Attached hereto is a marked-up version of the changes made to the Drawings and to the claims by the current amendment. The attached version is captioned **"VERSION WITH MARKINGS TO SHOW CHANGES MADE."**

Application No. 09/634,507

VERSION WITH MARKINGS TO SHOW CHANGES MADE

FIG. 1b

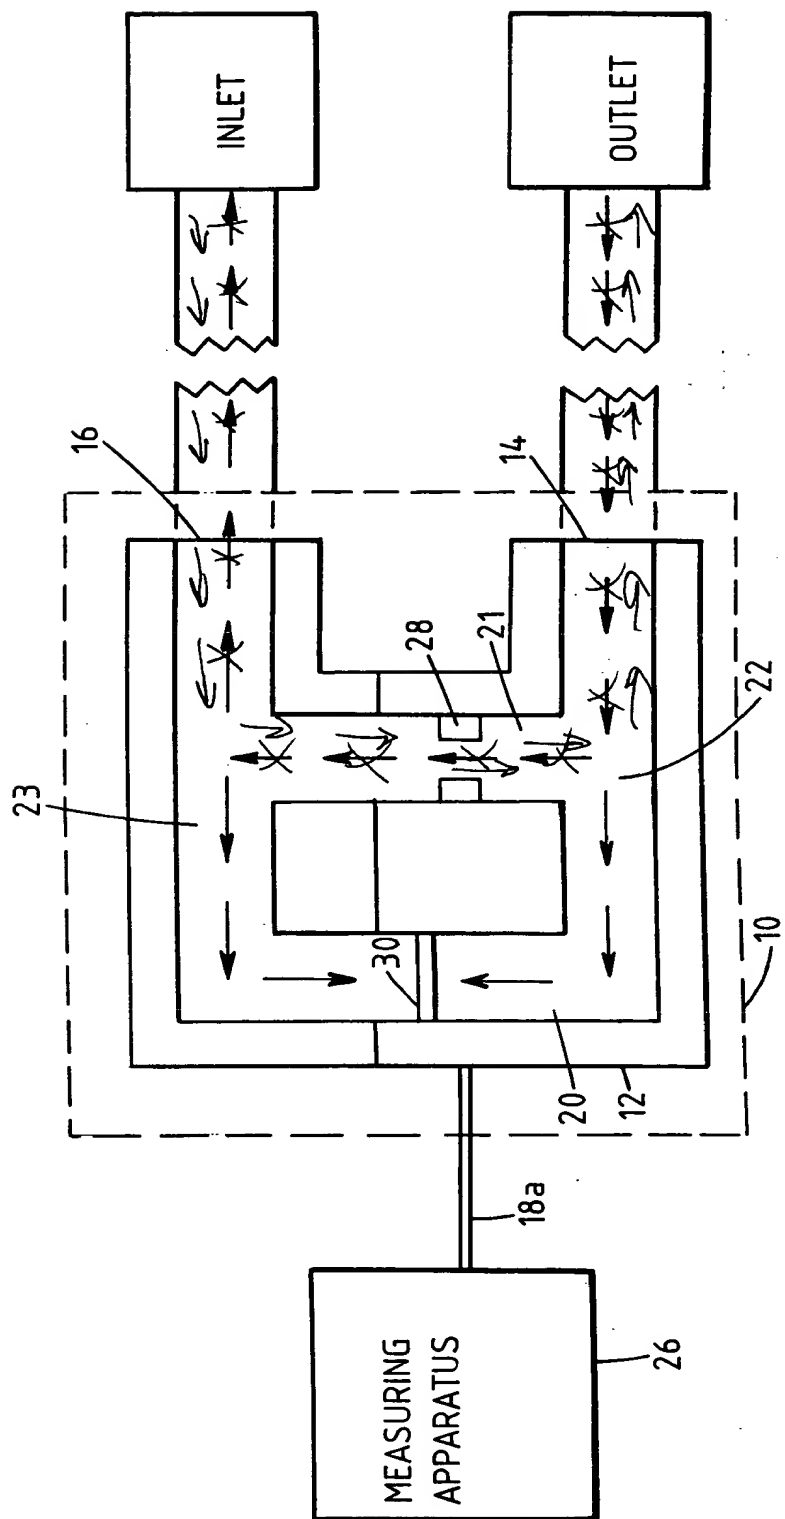
With the agreement of the Examiner, applicants propose to amend Figure 3 of the Drawings by changing the reference numeral 22 to the reference numeral 21 as shown by the red ink notations on the accompanying copy of Figure 3. Also with the agreement of the Examiner, applicants propose to amend Figure 1b of the Drawings by changing the direction of the arrows in the channels 21, 22, and 23 as shown by the red ink notations on the accompanying copy of Figure 1b.
